**Responses to Request for Additional Information
Model No. WE-1 Package
Docket No. 71-9289**

**Enclosure (1)
Responses to NRC RAIs**

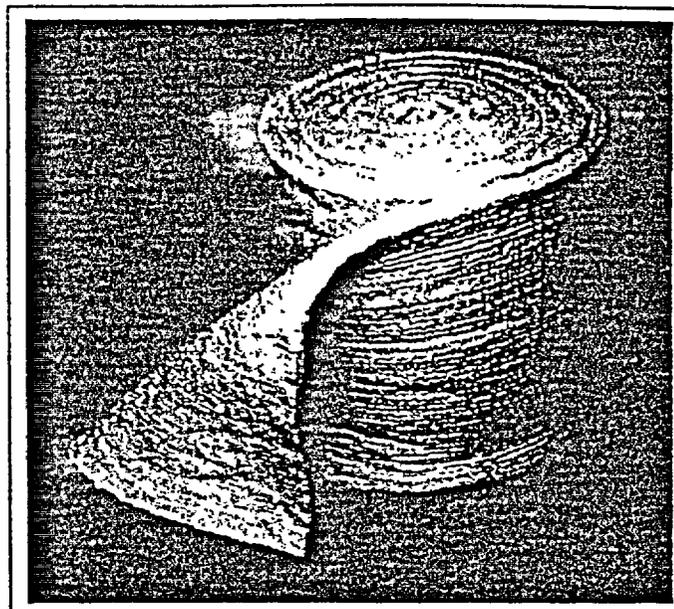
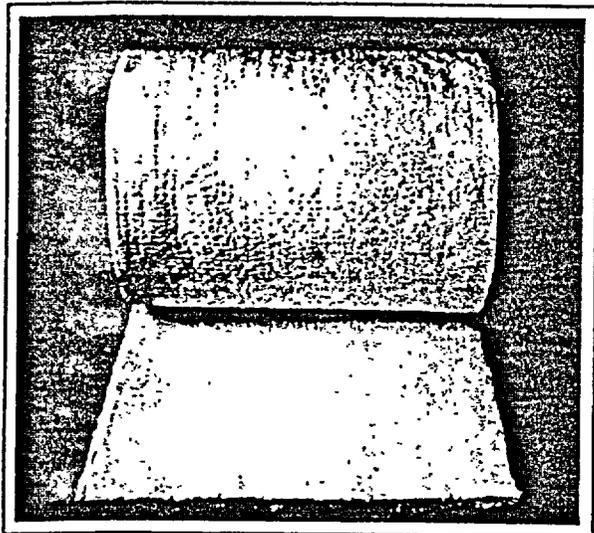
1-3 *Provide the manufacture data sheet for the thermal insulation.*

Staff needs to verify the compatibility of insulation material(s) with the carbon and stainless steel components of the canister, inner container, and the strongback.

Figure 2.10-5 Finite Element Model for Armor Plate Inner Container
Original Configuration With All Three Clamps

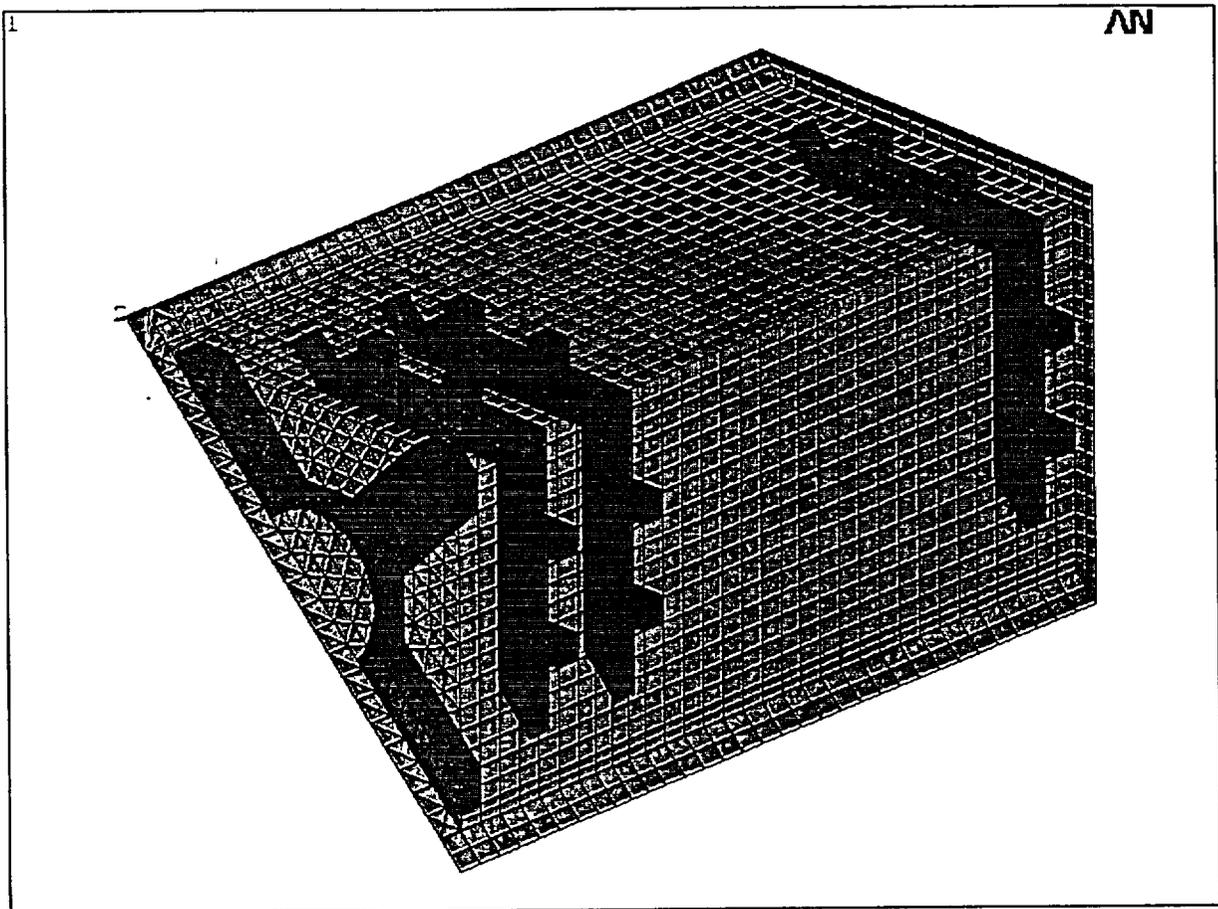
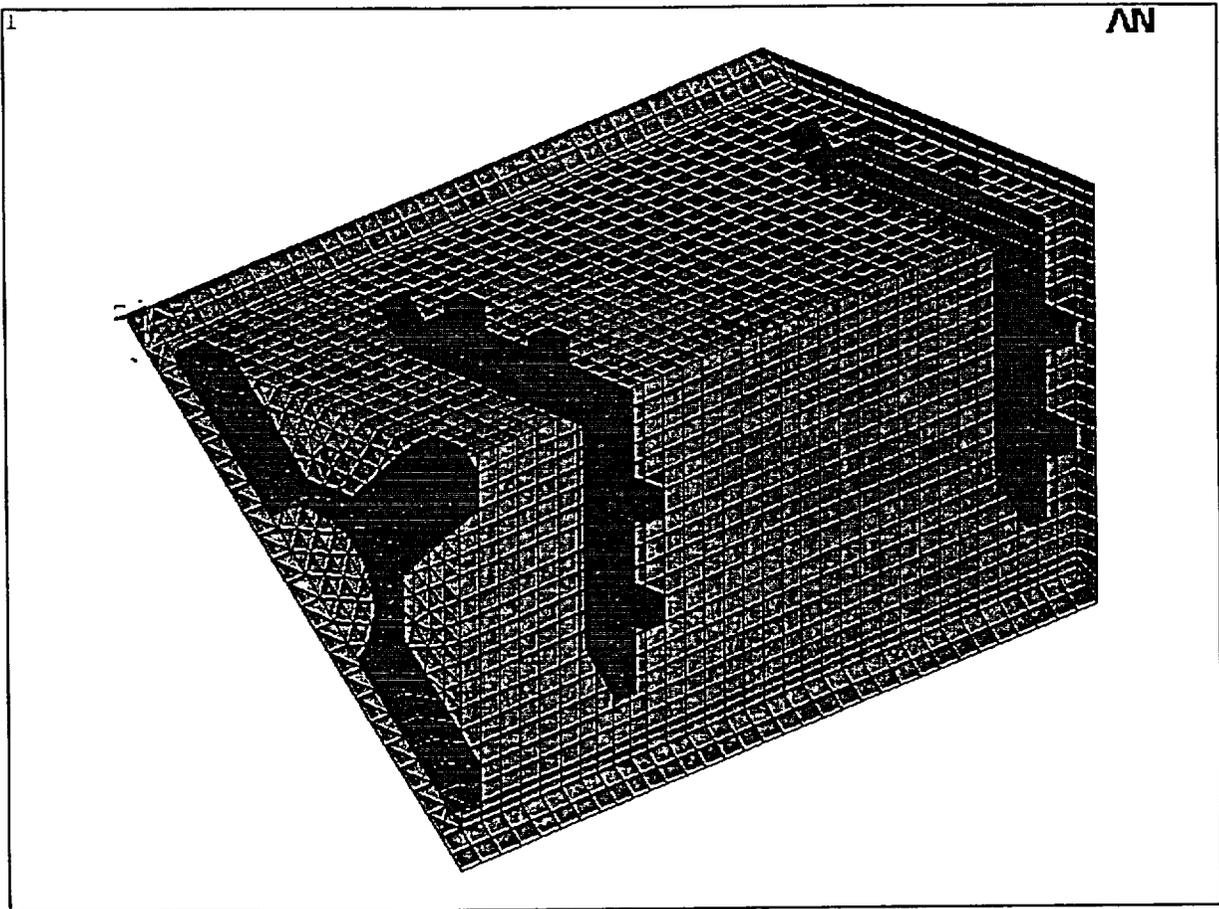
- 2-10 *Provide the bases of the statements in Section 2.10.2.8, regarding the adverse effects of the removal of one clamp in the Pathfinder fuel canister arrangement. The statements relate to the effects on the stiffness and resulting impact accelerations, and the adequacy of the high strength bolts in the new configuration.*

Section 2.10.2.8 discusses the effects of removing one clamp at the end, but does not provide any bases to support the statements related to the effects on the stiffness and the g-level, and the replacement of the low-strength bolts with the high-strength bolts. This information is required to verify that the package meets 10 CFR 71.33 requirements.

the inner container. This was verified by the computer analysis. There is no change in the beam bending stiffness with or without the end clamp. Also, when one considers, all of the other structural members, the change in the overall stiffness is insignificant. The stiffness calculation methods, analysis, and result are included in Section 2.10.2.8 of the SAR.

A conservative finite element stiffness analysis was performed for the HY-80 armor plate inner container with and without the end clamp. Computer program ANSYS was used for the stiffness calculations. The box stiffness in the diagonal direction was calculated. Due to structural symmetry, half of the box is analyzed. ANSYS 20-noded SOLID95 element type was used. Figure 2.10-5 shows the finite element model for original configuration i.e., with end clamp. Figure 2.10-6 shows the finite element model with end clamp removed. A listing of the ANSYS commands for the modified configuration with one clamp removed is provided. The ANSYS commands for the original configuration model can be obtained by removing three lines of commands starting with the comment 'remove 1st clamp from model.' The results of the analysis are:

Figure 6-1b
Pathfinder Fuel Assembly Configuration

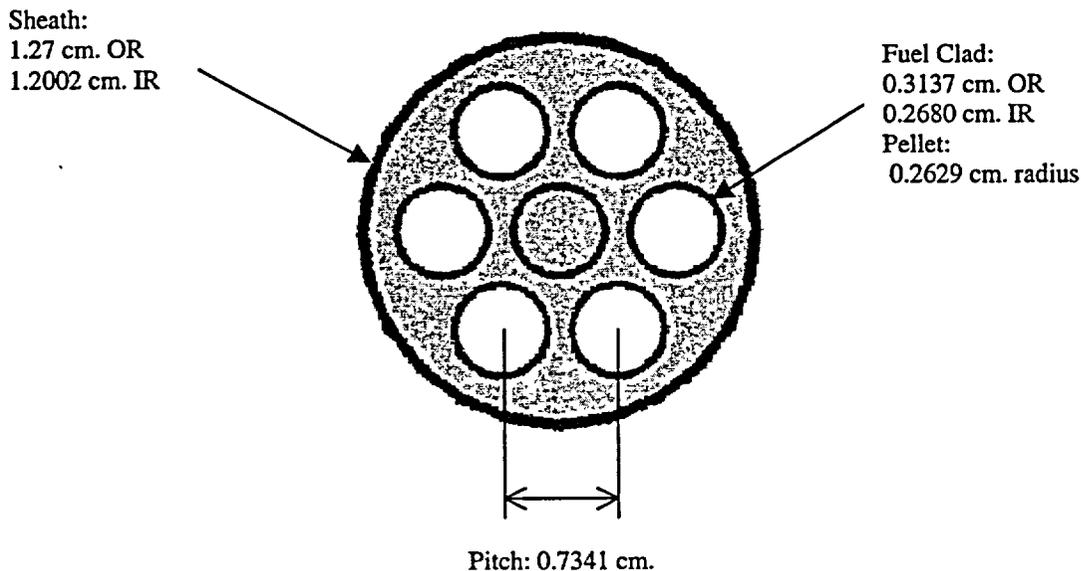
- 6-3 *Revise the diagram in Figure 6-1b to specify the dimensions used in the KENO criticality model.*

Figure 6-1b has been revised to show center-to-center pin pitch, fuel clad IR and OR, Sheath IR and OR, and Fuel pellet radius.
